# UNITED STATES PATENT AND TRADEMARK OFFICE

APPLICATION NO.	FILING DATE	FIRST NAMED INVENTOR	ATTORNEY DOCKET NO.	CONFIRMATION NO.
10/652,924	08/28/2003	Hiroyuki Koyama	03496/LH	2489
1933	7590	11/04/2005	EXAMINER	
FRISHAUF, HOLTZ, GOODMAN & CHICK, PC 220 5TH AVE FL 16 NEW YORK, NY 10001-7708			COLILLA, DANIEL JAMES	
			ART UNIT	PAPER NUMBER
			2854

**Office Action Summary**

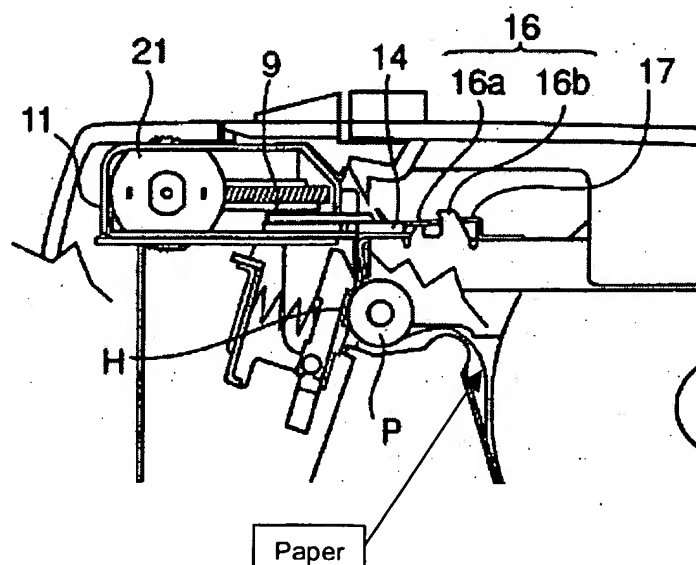
With respect to claim 1, Hosomi et al. discloses a printer unit with a guide path as shown by the paper in the Figure below taken from Figure 4 of Hosomi et al.:

Hosomi et al. further discloses a printing section having a platen P and a printhead H, a cutter section with a stationary blade 14 and a movable blade 9 with the guide path located therebetween. Figure 5 of Hosomi et al. shows a first unit located on one side of the guide path and having the platen P and the stationary blade 14 and a second unit located on the other side of the guide path having the printhead H and the movable blade 9. Hosomi et al. additionally discloses a connecting mechanism 8,12 which removably connects the first unit to the second unit.

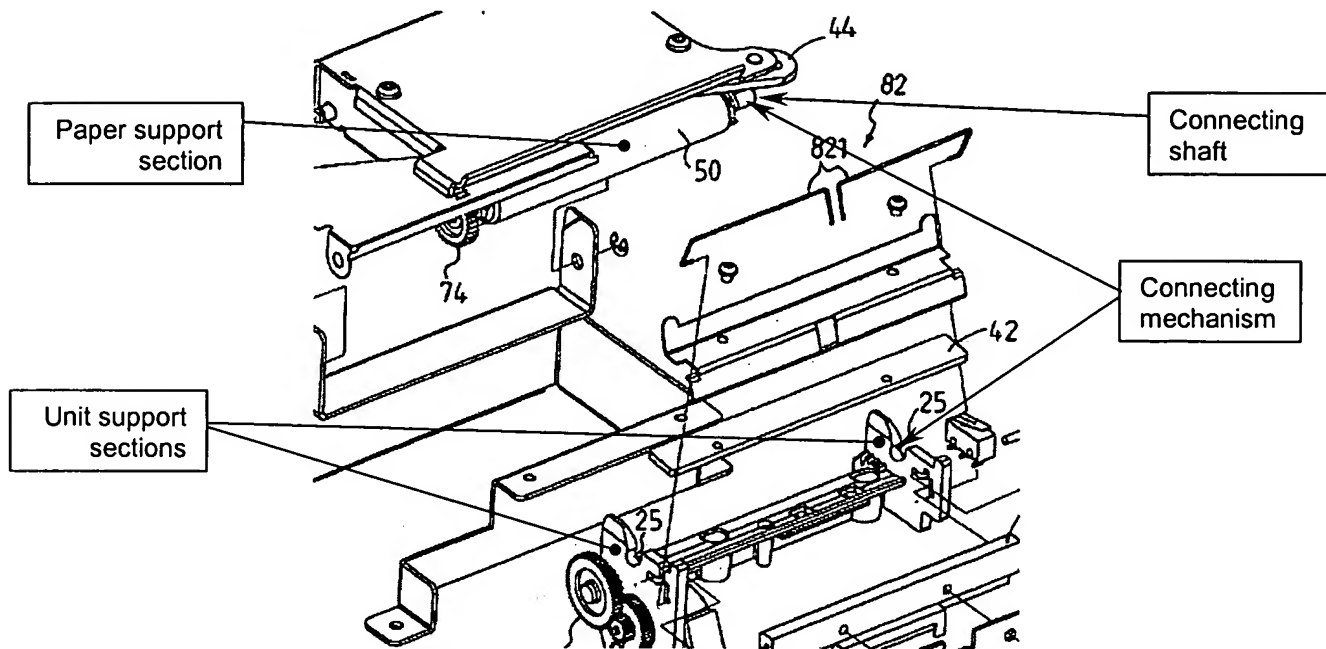
With respect to claim 2, the frame of the printer that surrounds the notch 25 is a unit support section that removably supports the first unit as shown below in the Figure taken from Figure 2 of Robinson:

With respect to claim 3, the connecting mechanism has a plurality of connecting shafts (only one is shown in the above Figure) mounted in the first unit, the axes of which are orthogonal to the direction of the guide path of the paper, and a plurality of support sections provided in the second unit for fitting the connecting shafts.

With respect to claim 4, the platen 50 has a paper support section and a support shaft at either end of the paper support section to serve as one of the connecting shafts as shown in the above Figure.
